# Memorandum

**RE:** **P.Z. 05-2022 Gateway Golf Center (Gateway Studios, LLC)**: A request for a zoning map amendment from the “PC” Planned Commercial District to a new “PC” Planned Commercial District for 22.78 acres located on the north side of Outer 40 Road (17V630059)

## Planning Commission Staff Report

Re: PZ 05-2022 (17795 N. Outer 40 Road) – Response Letter  
(Stock Project No. 221-7165)

Figure 4: Preliminary Development Plan

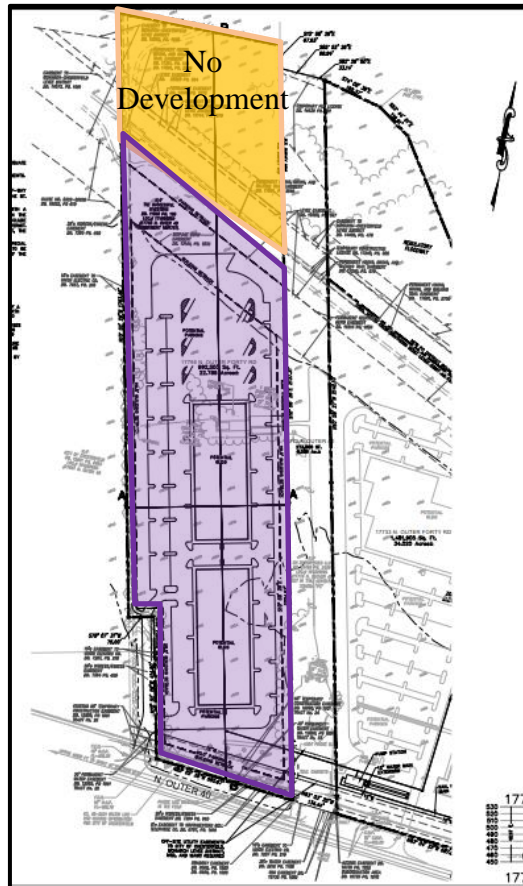
As per City of Chesterfield Unified Development Code, a Planned Commercial District requires a 35-foot setback from adjoining property designated as Parks & Recreation in the City Comprehensive Land Use Map. The property west of the subject site is designated as parks and recreation. The applicant has requested a 25’ ft setback and zero foot parking setback from the west boundary of the PC District. The request for modification requires 2/3 of Planning Commission vote for approval. It should be noted that the applicant has actively been coordinating with the City on revisions to existing access easements to align with the City’s desires and Staff recommends approval of the modification.

**PRELIMINARY DEVELOPMENT PLAN**

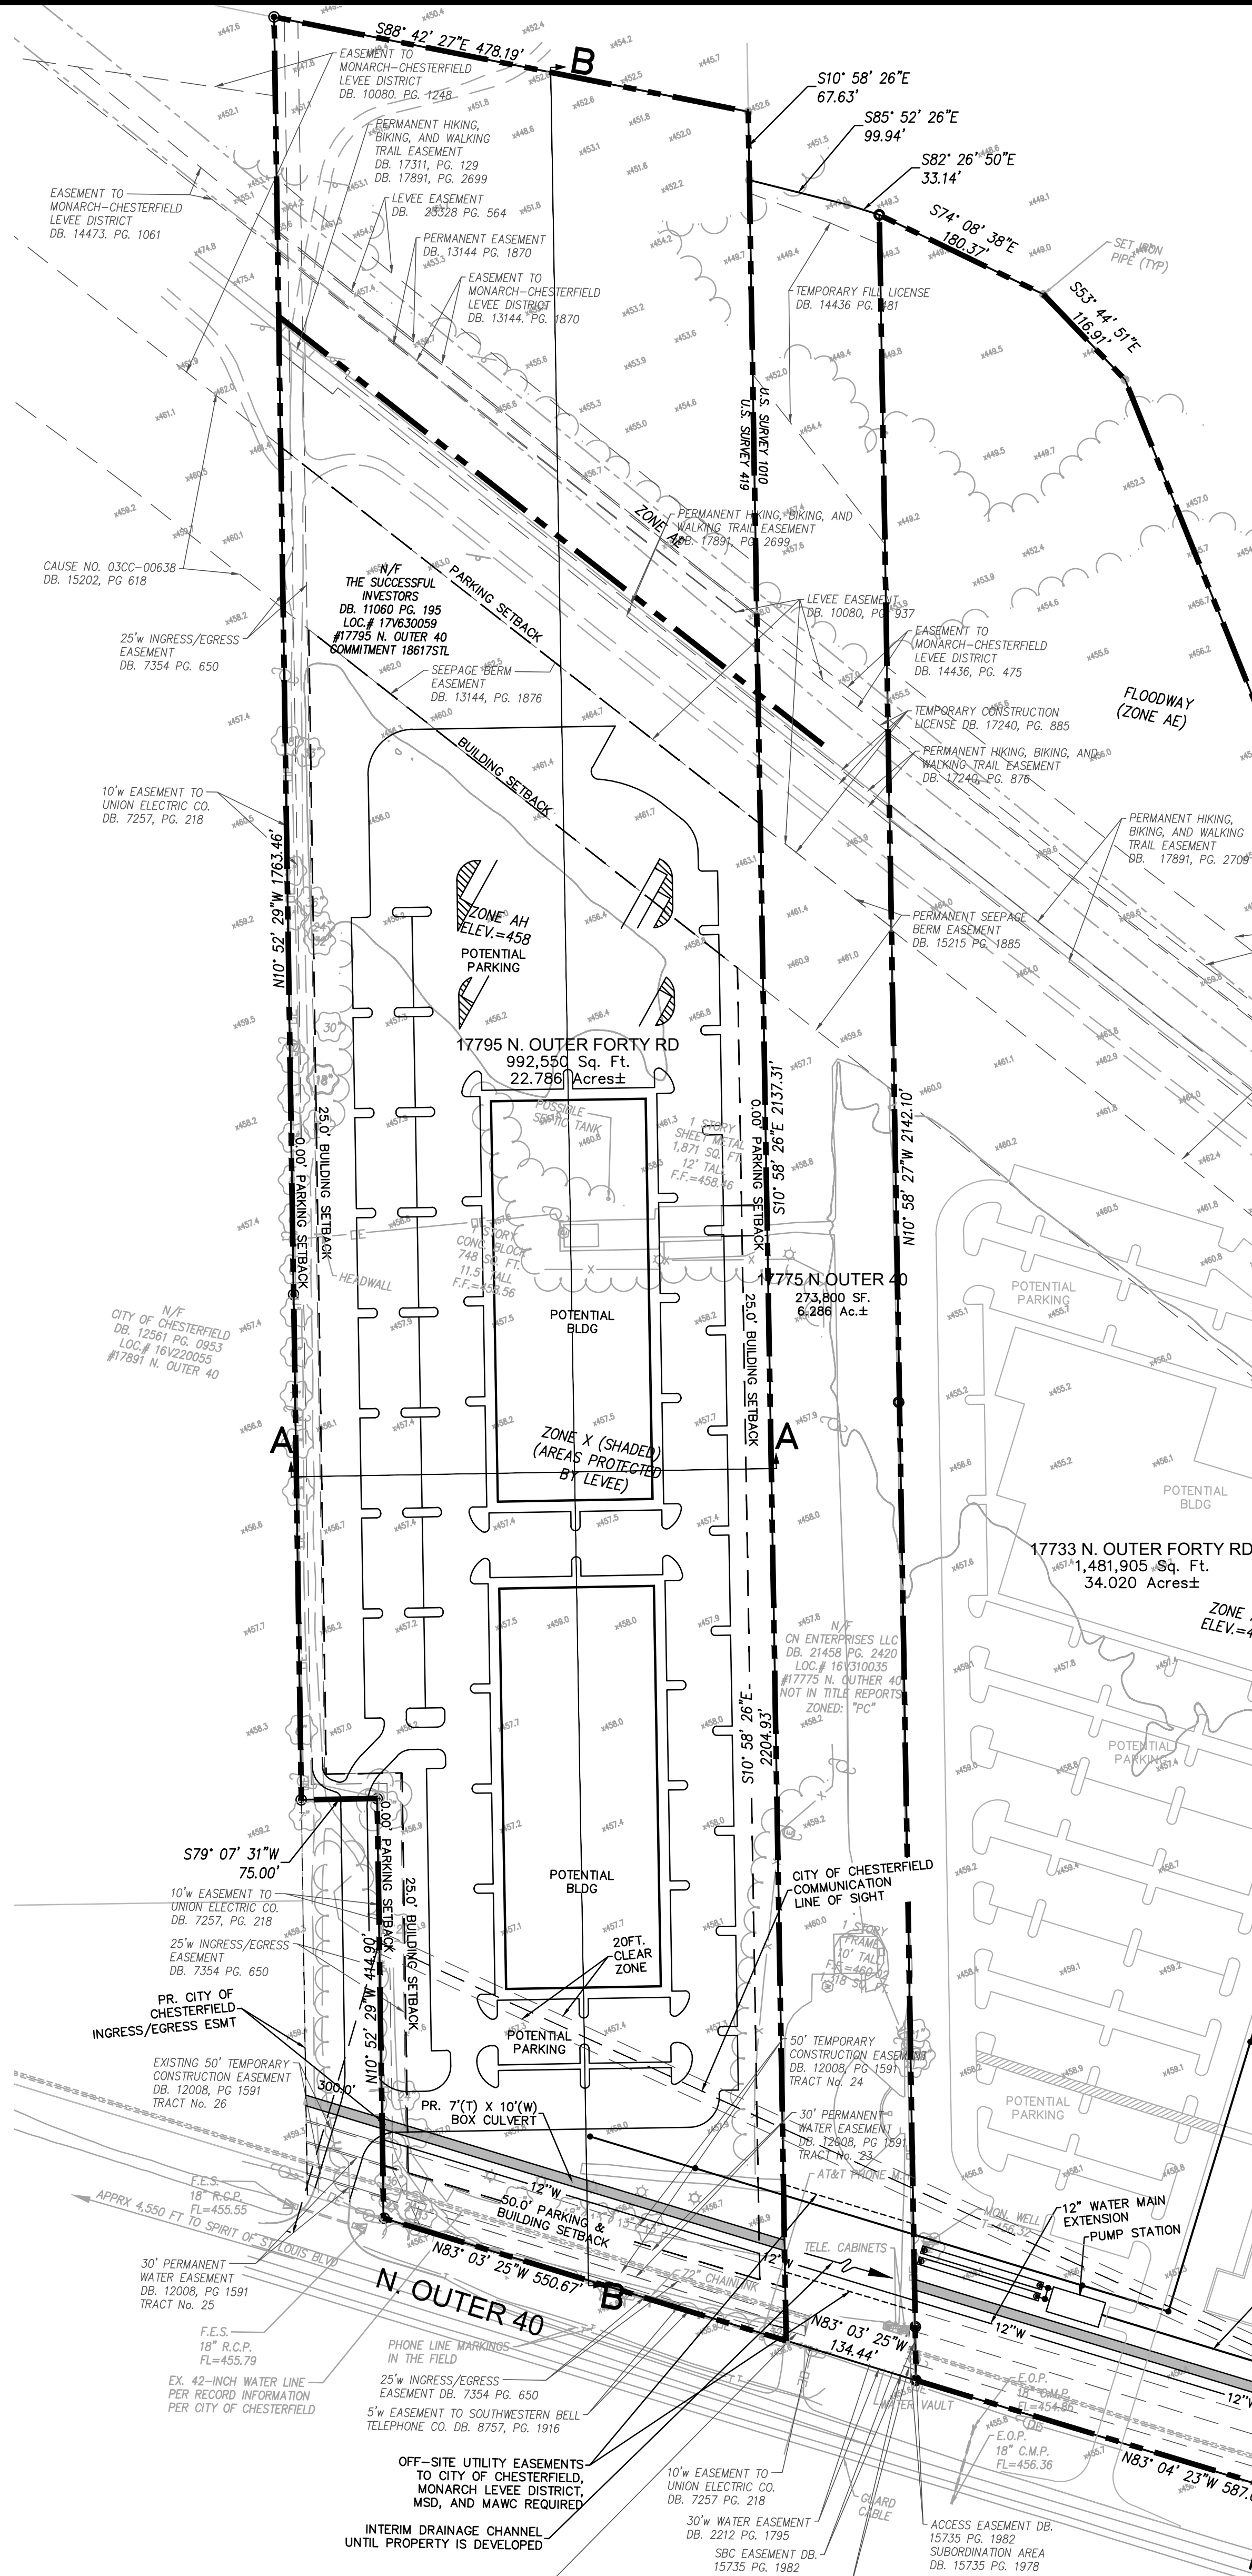
1. It is understood that the proposed entrance as shown on the Preliminary Plan will serve the City's property, the development, and the existing 25-foot-wide ingress/egress easement. Since there will need to be an easement on the City's property to cover this, please depict and label the proposed easement on the Preliminary Plan.

2. For the City of Chesterfield communication line of sight, a 20-foot-wide clear zone centered on the alignment shown is required. Anything located in the clear zone would need to be under 30 feet in height. The current preliminary plan only depicts a 10-foot-wide clear zone. Please revise the plan to provide a 20-foot-wide clear zone.

**Response: A proposed Access Easement from the City of Chesterfield has been added to the Preliminary Site Development Plan.**

**Response: We have revised the Preliminary Development Plan to comply w/ 20-foot Wire Clear Zone.**
